## FCC Class II Permissive Change Request Letter

RE: FCC Permissive II Change Request for Company: HUIZHOU FORYOU GENERAL ELECTRONICS CO.,LTD.

FCC ID: 2AEIN-4154493C1

Add model: 4275486C1 based on the original project.

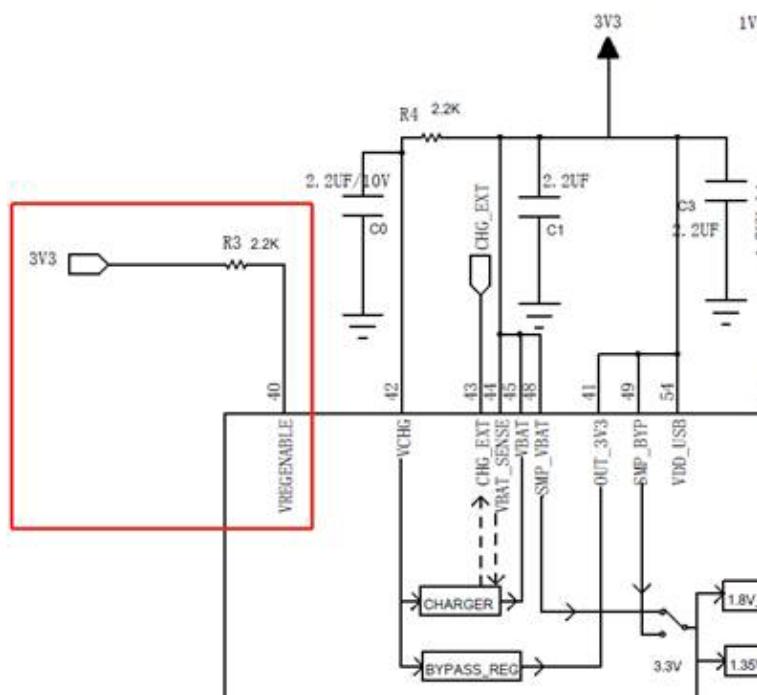
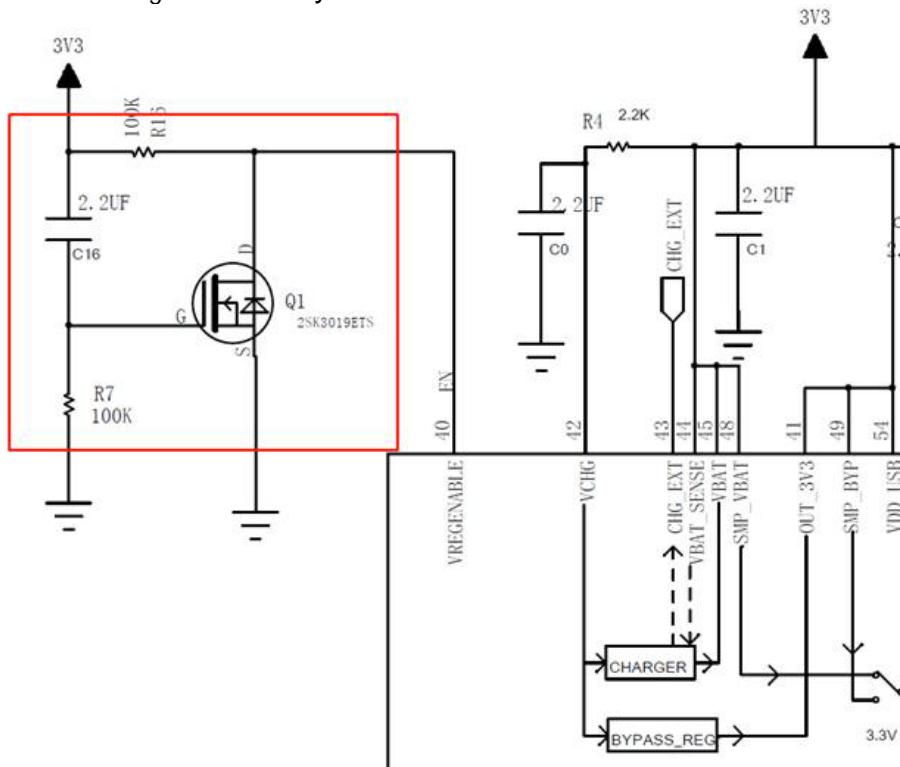
Compared with the model 4154493C1, the model 4275486C1 is canceled the DVD movement and DVD play function, add power amplifier and change a plate, canceled SXM function. The Bluetooth RF chip's power supply circuit add the delay circuit. RF parameters didn't change.

Before the change:

After the change: Add delay circuit
